<b>Title - Sujet</b> DUAL-COLOR MWIR IMAGER	
<b>Solicitation No. - N° de l'invitation</b> W7701-166079/A	<b>Amendment No. - N° modif.</b> 003
<b>Client Reference No. - N° de référence du client</b> W7701-166079	<b>Date</b> 2015-10-05
<b>GETS Reference No. - N° de référence de SEAG</b> PW-\$QCL-029-16542	
<b>File No. - N° de dossier</b> QCL-5-38151 (029)	<b>CCC No./N° CCC - FMS No./N° VME</b>
<b>Solicitation Closes - L'invitation prend fin</b> <b>at - à 02:00 PM</b> <b>on - le 2015-10-13</b>	
<b>Time Zone</b> Fuseau horaire Heure Avancée de l'Est HAE	
<b>F.O.B. - F.A.B.</b> Specified Herein - Précisé dans les présentes <b>Plant-Usine:</b> <input type="checkbox"/> <b>Destination:</b> <input type="checkbox"/> <b>Other-Autre:</b> <input checked="" type="checkbox"/>	
<b>Address Enquiries to: - Adresser toutes questions à:</b> Champoux, Nicolas	
<b>Buyer Id - Id de l'acheteur</b> qcl029	
<b>Telephone No. - N° de téléphone</b> (418) 649-2821 ( )	<b>FAX No. - N° de FAX</b> (418) 648-2209

### AMENDMENT 003

- Questions and answers 11 and 12;
- Modifications to the Request for Proposals (RFP)

**Figure 1: Example of imaging bands B1 and B2 on a single FPA**

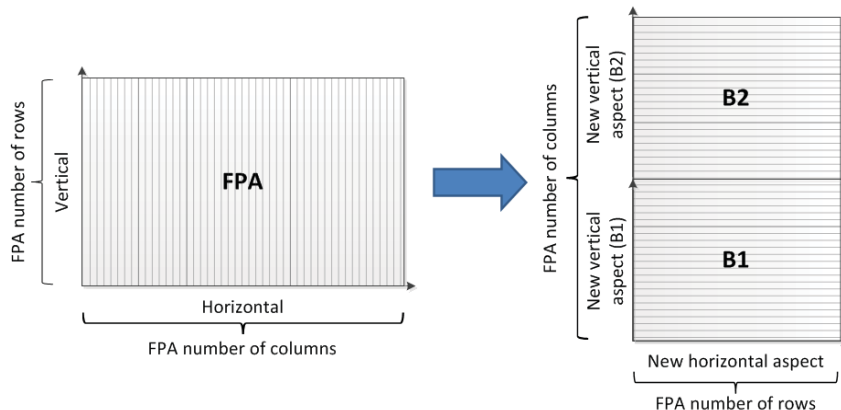
**Q11:** “Is it acceptable to propose a solution were each band be imaged by 1.31M pixels? It correspond to regular HD format of 1280 x 1024 pixels.”

- **Note 6: Acceptable equivalent:** It is an accepted alternative to image each band of the 2C-IR imager to a HD detector of format 1280x1024 pixels. Using HD detectors implies that each band of the 2C-IR shall have a resolution of 1280 horizontal x 1024 vertical pixels.

**A11:** It is an accepted alternative to image each band of the 2C-IR imager to a HD detector of format 1280x1024 pixels. Using HD detectors implies that each band of the 2C-IR shall have a resolution of 1280 horizontal x 1024 vertical pixels. No further image size reduction will be authorized by the TA.
